Monthly Specification Update

Intel® Server Boards S2600WP Family
Intel® Server Systems H2000WP Family

Intel Order Number G64830-005

May, 2013

18. Chassis sag to 2.0 mm when fully loaded in rack

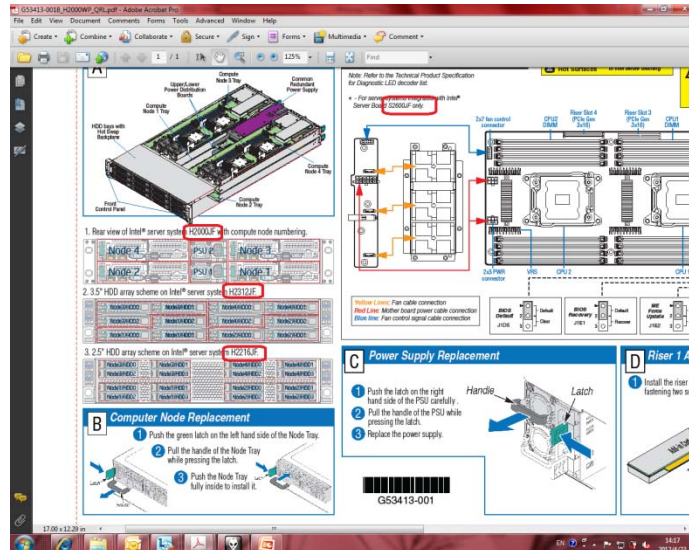
Problem	Chassis fully loaded (34kg) will sag about 2.0 mm when installing in rack
Implication	The max sag (~2.0mm) will happen at the rear of the chassis.
Status	This issue is fixed in all 1600W system SKUs.
Workaround	leave 1U space under H2000WP chassis when install in the rack or load system device shorter than 21" under H2000WP chassis adjacently.

19. Incorrect picture titles in Chassis Quick Reference

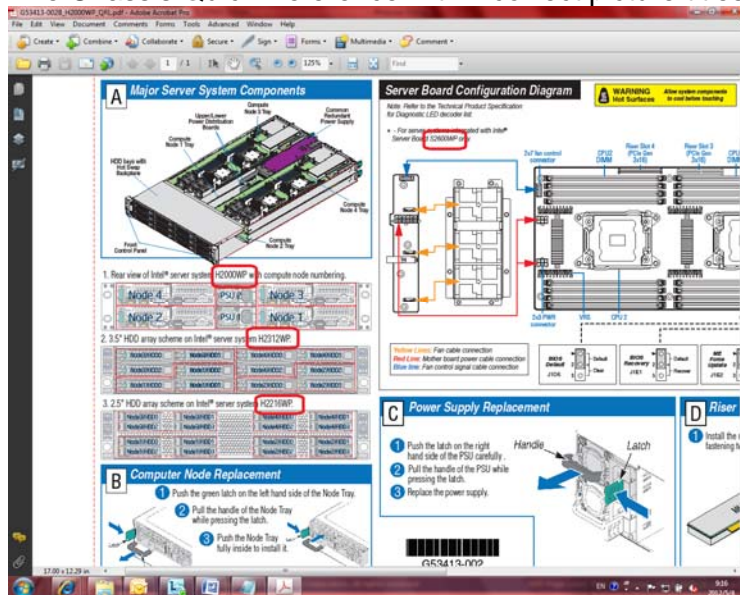
Problem	The Intel® Server System H2000WP family Chassis Quick Reference(document ID G53413-001) has 4 incorrect picture titles as shown below. The correct title name should be "H2000WP", "H2312WP" "H2216WP" and "S2600WP". All schemes and configuration diagrams are correct for H2000WP. The impacted servers systems are listed below. The updated Chassis Quick Reference (document ID G53413-002) has fixed this problem. The impacted server systems are list in the table
---------	---

The Chassis Quick Reference with incorrect picture titles

The Chassis Quick Reference with updated picture titles

Implication The picture tiles do not match the pictures.

Status This issue was fixed with G53413-002.
